MEMORANDUM

APPLICATION FOR FINAL SUBDIVISION APPROVAL 1597 NEW LONDON TURNPIKE: 2 LOT SUBDIVSION MEETING DATE: OCTOBER 15, 2024

RE: 1597 NEW LONDON TURNPIKE - 2 LOT SUBDIVISION

Re: 1597 New London Turnpike 2-Lot Subdivision

ATE: 5-10-24 CALE: SHEET 6 OF 8

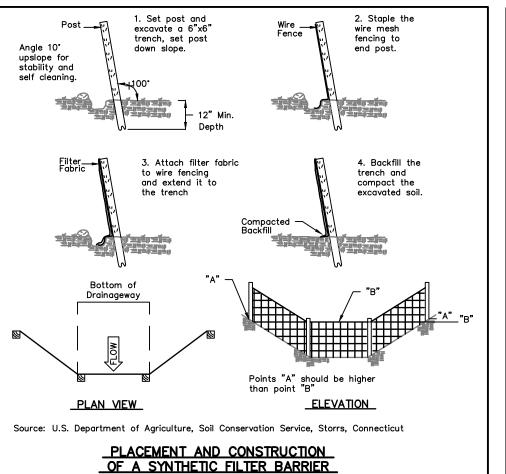
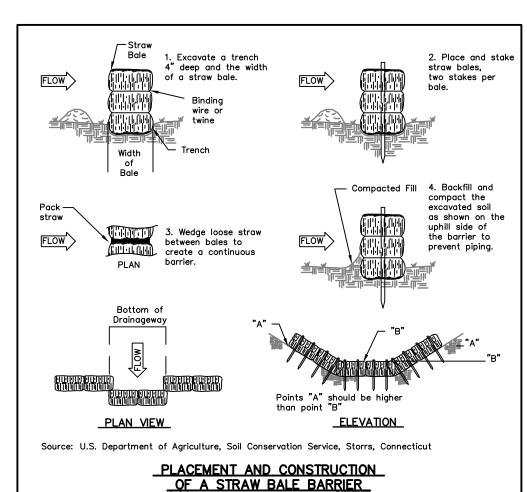
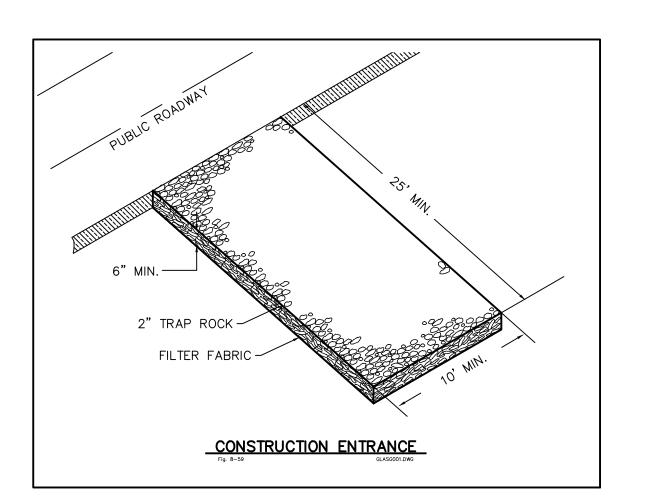
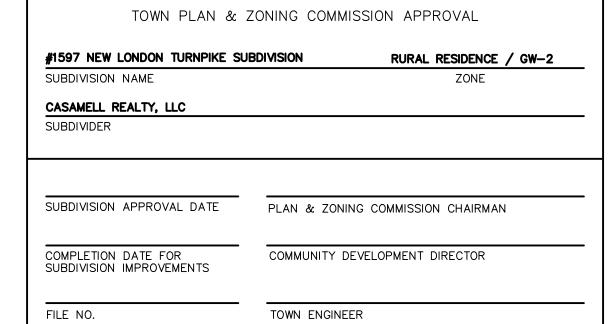
- The computations of the water quality volume (WQV) for Area 'B' on sheet 6 of 8 should be corrected to include the computation of the R factor per the CTDEEP Stormwater Quality Manual.
